MAINE TURNPIKE AUTHORITY

ADDENDUM NO. 2

CONTRACT 2022.07

INTERCHANGE IMPROVEMENTS

SHEET NUMBER: QN-01
CONTRACT: 2022.07
2 OF 735

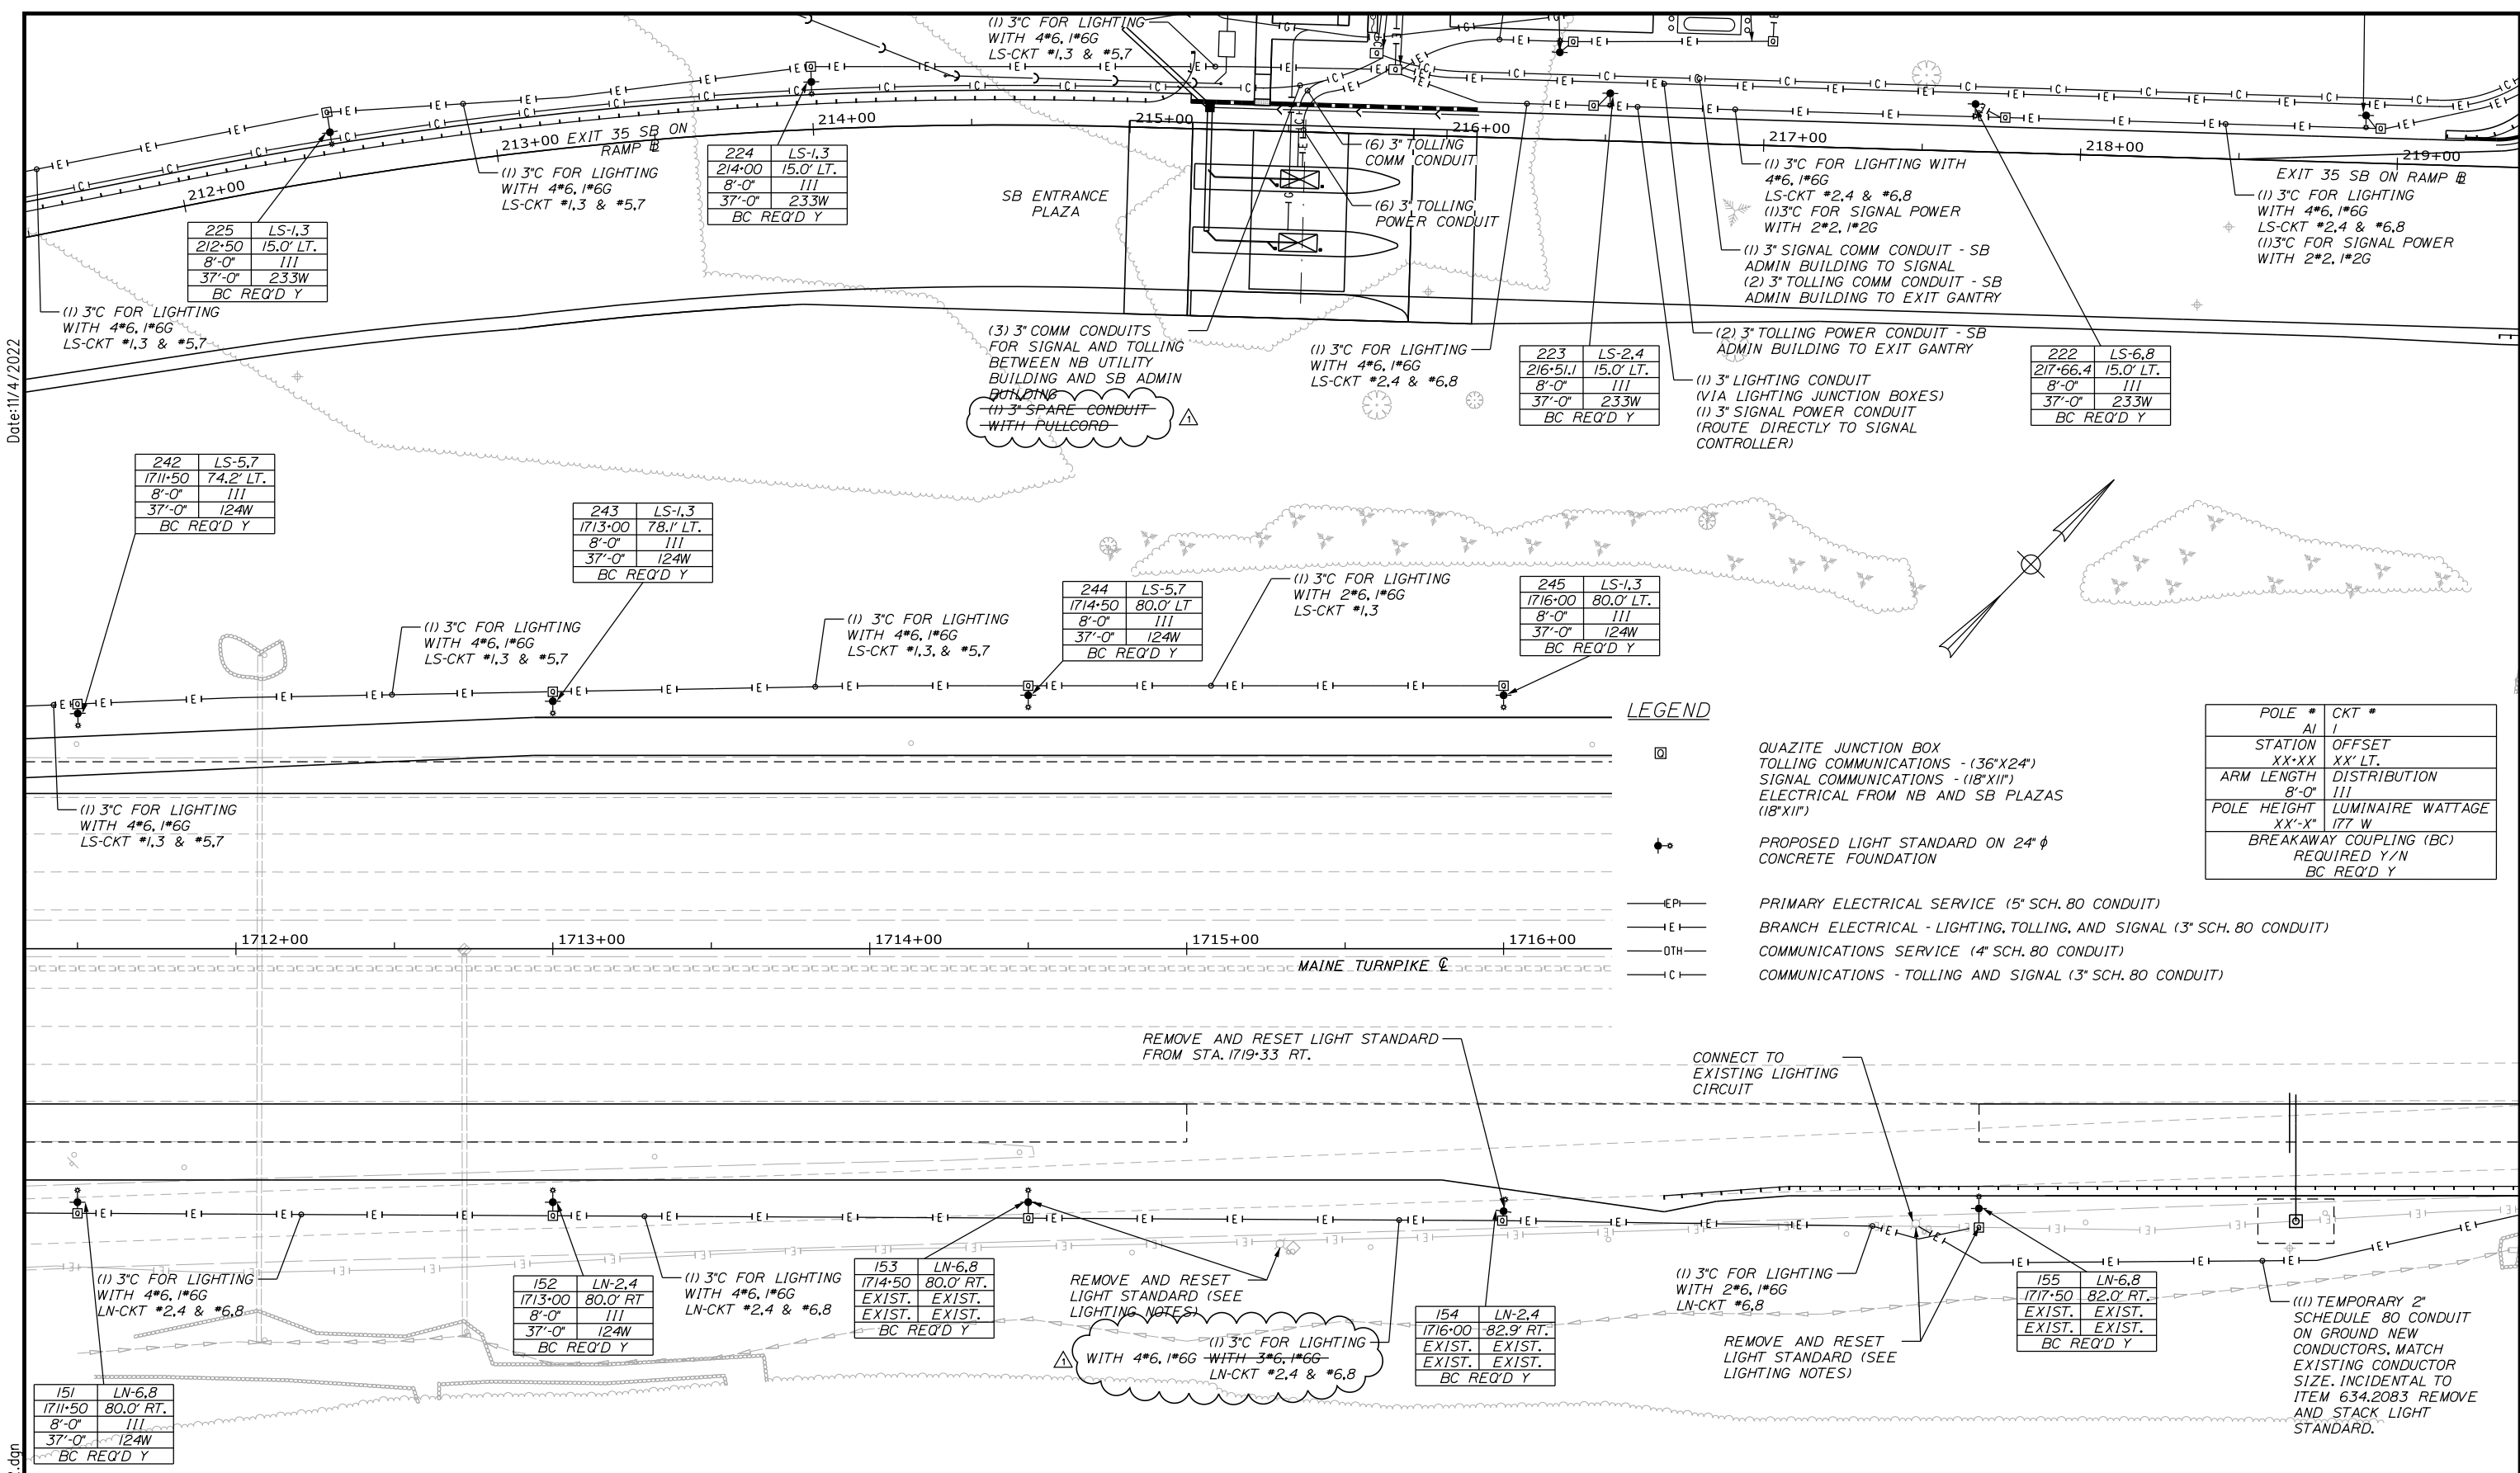
- Plan Sheet 2 of 735, ESTIMATED QUANTITIES 1, has been deleted in its entirety and replaced with Plan Sheet 2 of 735, included in this addendum.
- Plan Sheets 254, 255, 256, & 262 of 735, POWER AND COMMUNICATION PLAN 8, 9, 10, 16, have been deleted in their entirety and replaced with Plan Sheets 254, 255, 256, & 262 of 735, included in this addendum.
- Plans Sheet 470 of 735, SB C-D ROADWAY, has been deleted in its entirety and replaced with Plan Sheet 470 of 735, included in this addendum.
- Plan Sheets 601, 603, & 608 of 735 GOOSEFARE BROOK CULVERT EXTENSION, have been deleted in their entirety and replaced with Plan Sheets 601, 603, & 608 of 735, included in this addendum.

20. On sheet 608 of the contract plans, the Goosefare Brook concrete collar is called out as item 603.28. There are 11 other collars that have significantly less scope. Will the MTA consider making the Goose Fare Brook Collar its own item.

Answer: Yes. Item 603.2801 - Reinforced Concrete Collar has been added for the Goosefare Brook culvert in the plans and special provisions in Addendum No. 2.

No.	Revision	By	Date
△	ADDED REINFORCED CONCRETE COLLAR	JRH	11/22

SHEET NUMBER: LP-09
254 OF 735

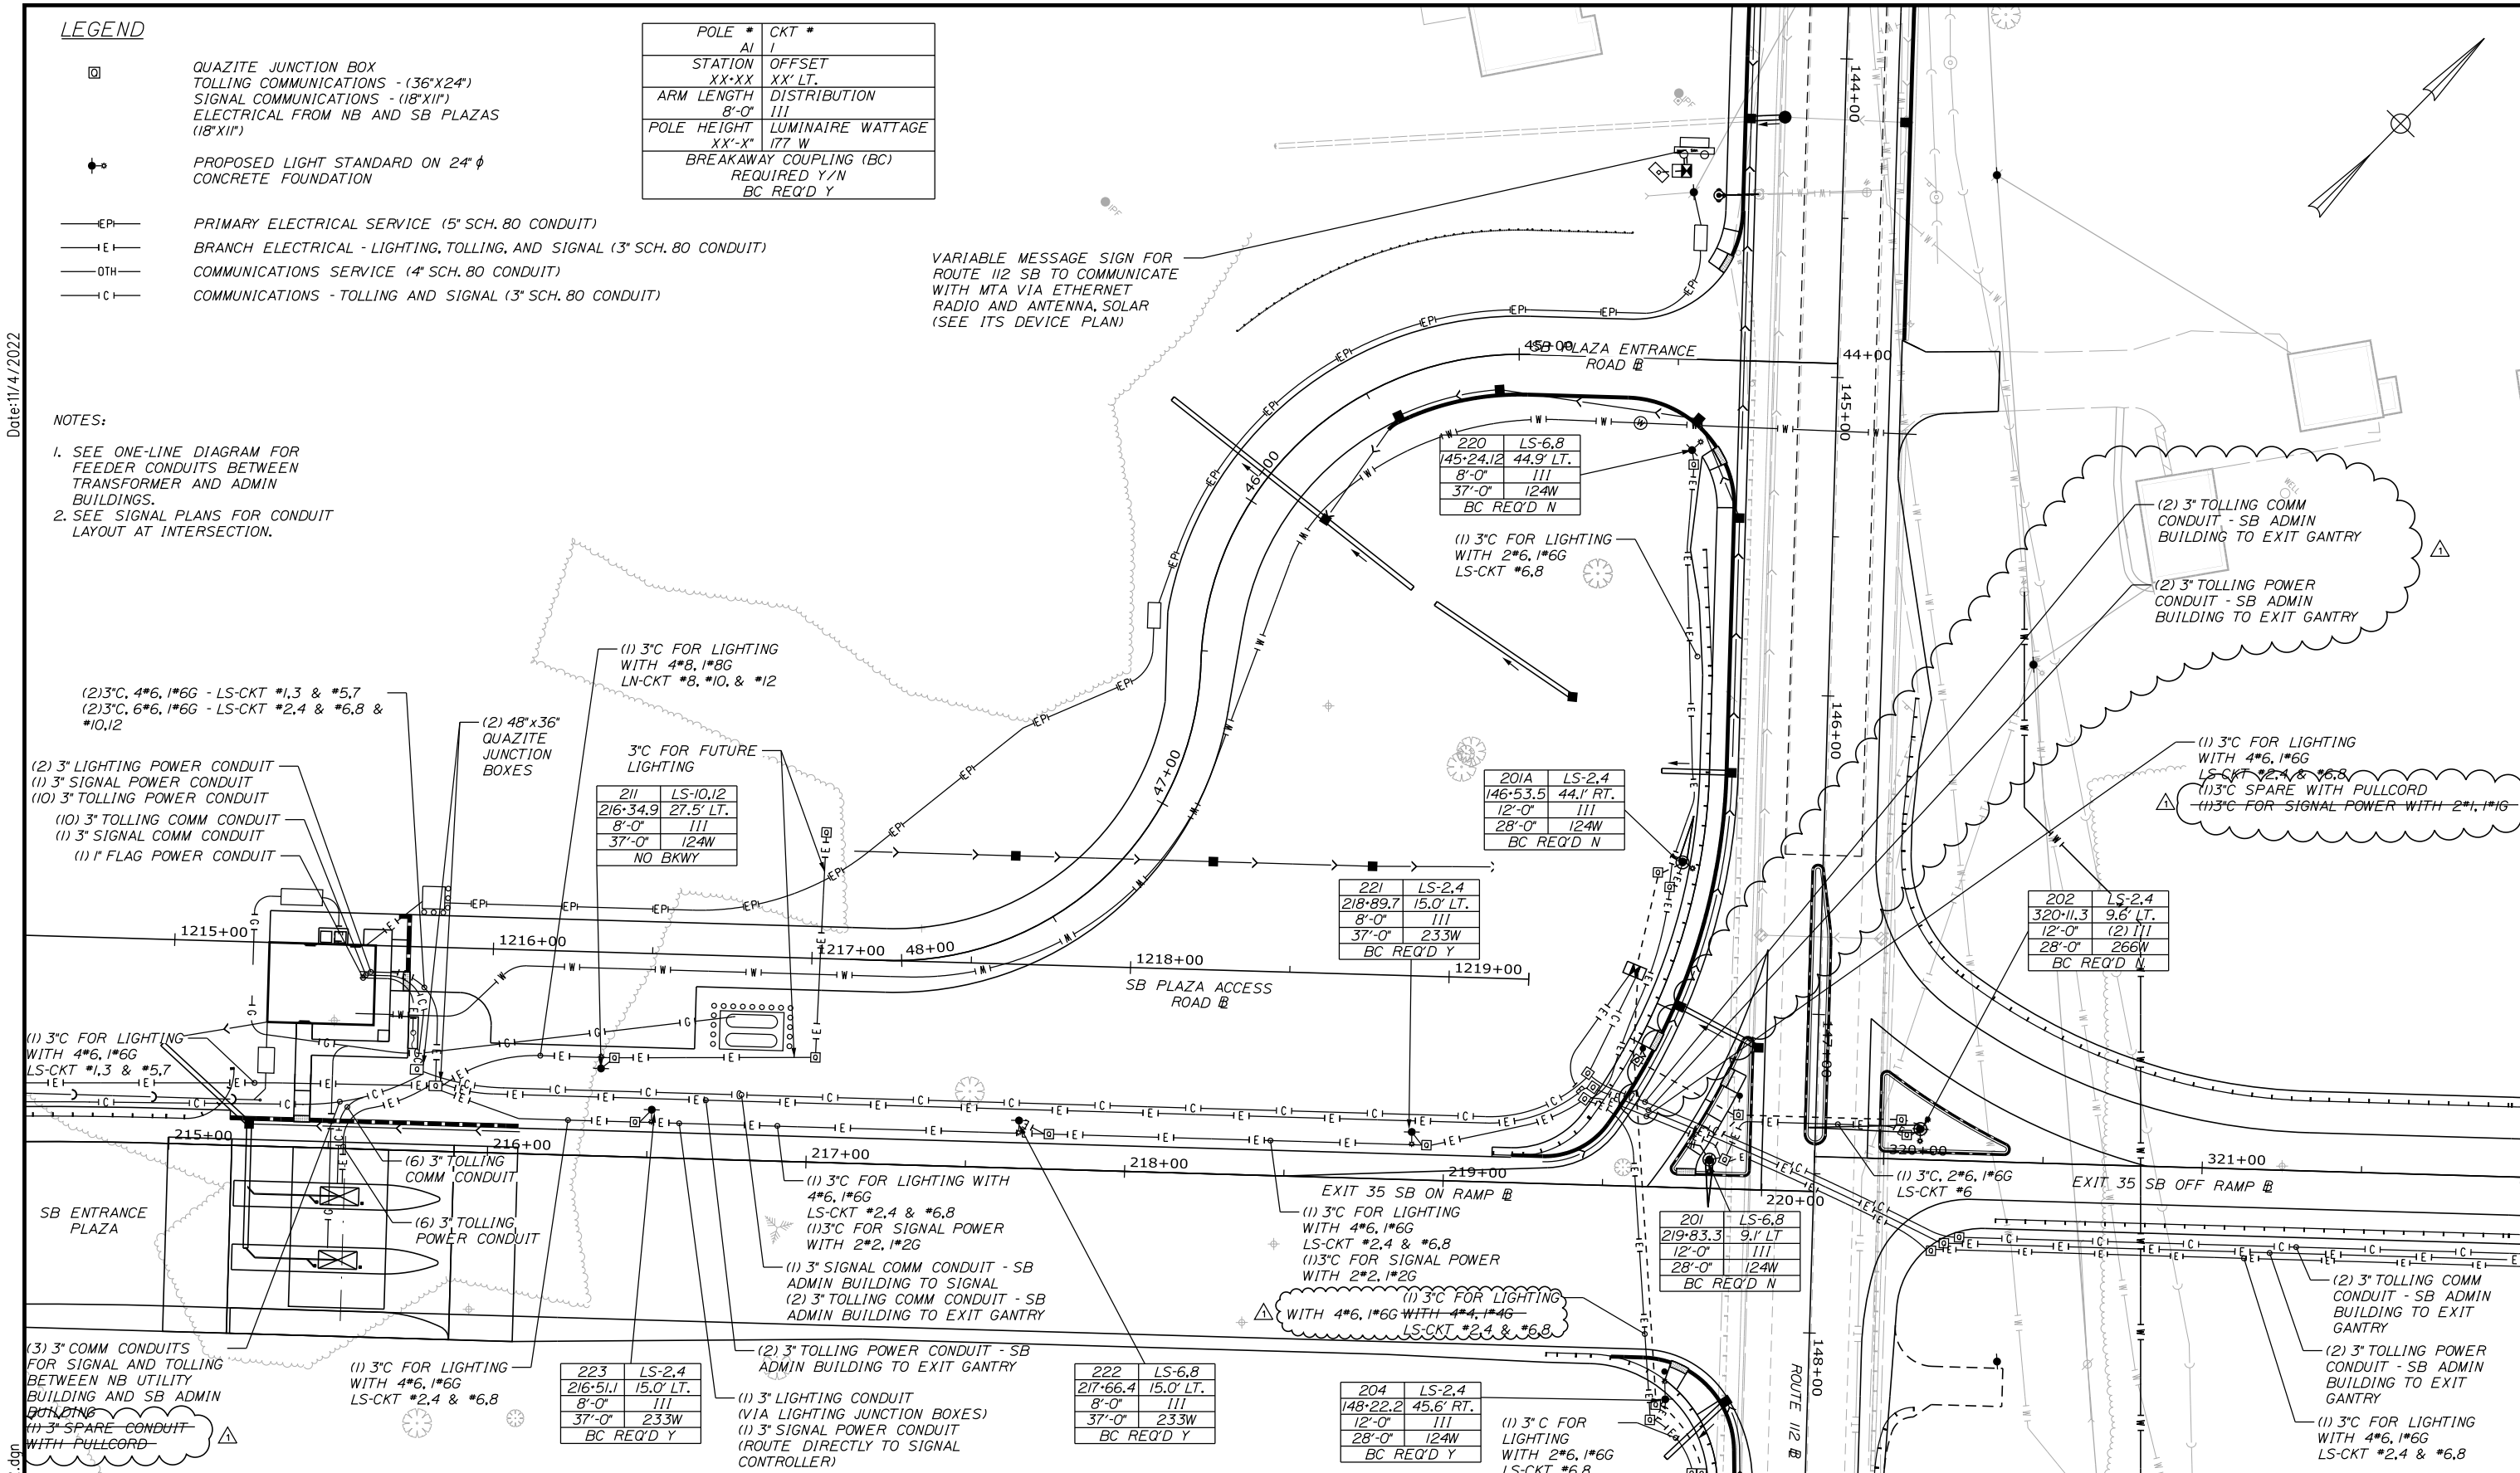
8. Question: Power & Communication drawing Plan 8 (Sheet 254) shows (3) 3" comm with (1) 3" spare. Sheet 7 shows (3) 3" only at station 211. Station 1710+80 shows (3) 3" comm & (1) 3" spare. Please make corrections as necessary.

9. Question: Power & Comm Plan 8 (Sheet 254) Station 1715+00 bottom of the page shows (1) 3" with 3 #6 and 1 #6G, however you show 4 circuits. Please clarify.

Answer: A spare conduit shall be installed at road crossings as called out. A 4th conduit is noted at the SB Plaza (Sta. 215+50, LT) and this note has been revised to delete 4th conduit on Sheet 254 in Addendum No. 2.

Answer: This note on Sheet 254 has been revised to show 4#6, 1#6G in Addendum No. 2.

No.	Revision	By	Date
Δ	REVISED NOTE	JRH	11/22
